**RE: Objection to Minto Resource Recovery Facility Proposal (SSD-5339)**

Origin Energy Retail (NSW) LPG Pty Limited current lessee of 22-26 Pembury Street, Minto, being a subsidiary of Origin Energy Limited (a publicly listed corporation) ('Origin') hereby tender our objections in respect of the Minto Resource Recovery Facility Proposal (SSD-5339) annexed to this letter as "Enclosure A".

# This is “Enclosure A”

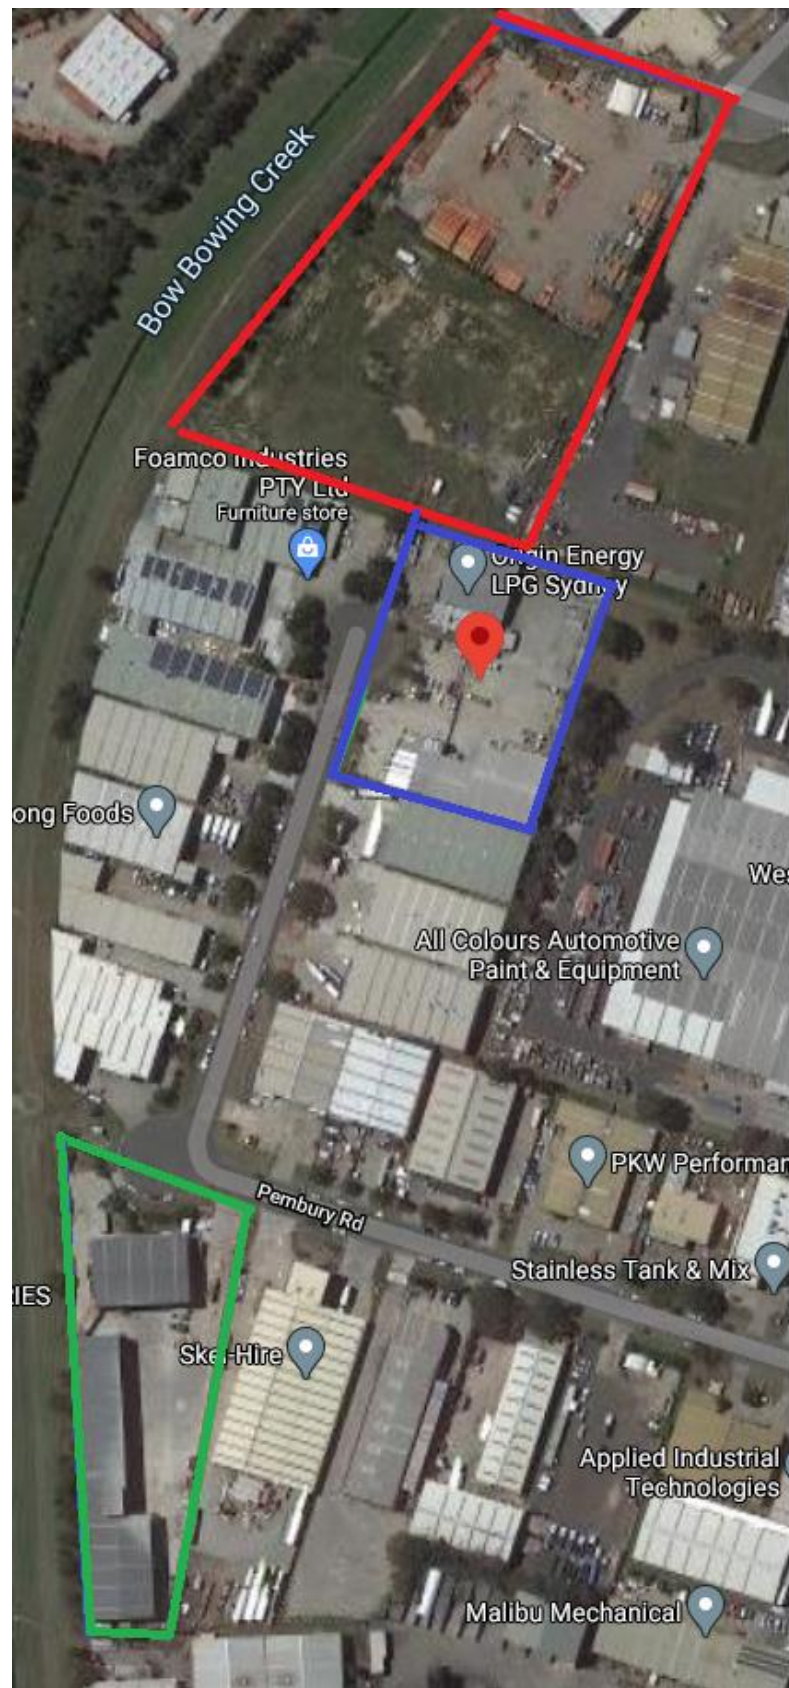
The report concedes that there are no monitoring devices near the Proposal site and that the OEH monitoring station located at Campbelltown West is 2.2km away from the site. It is submitted that the lack of site specific data renders the report assessment of existing air quality incomplete namely because the report omits to undertake any site specific readings.
